MICROCHIP PIC18F2420/2520/4420/4520

PIC18F2420/2520/4420/4520 Rev. A1 Silicon Errata Sheet

FIGURE 1: SCK PULSE VARIATION USING TIMER2/2

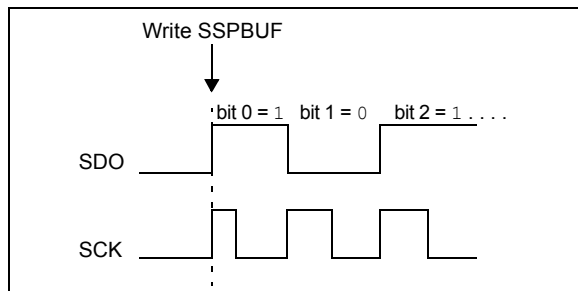
When the SPI is using Timer2/2 as the clock source, a shorter than expected SCK pulse may occur on the first bit of the transmitted/received data (Figure 1).

To avoid producing the short pulse, turn off Timer2 and clear the TMR2 register, load the SSPBUF with the data to transmit and then turn Timer2 back on. Refer to Example 4 for sample code.
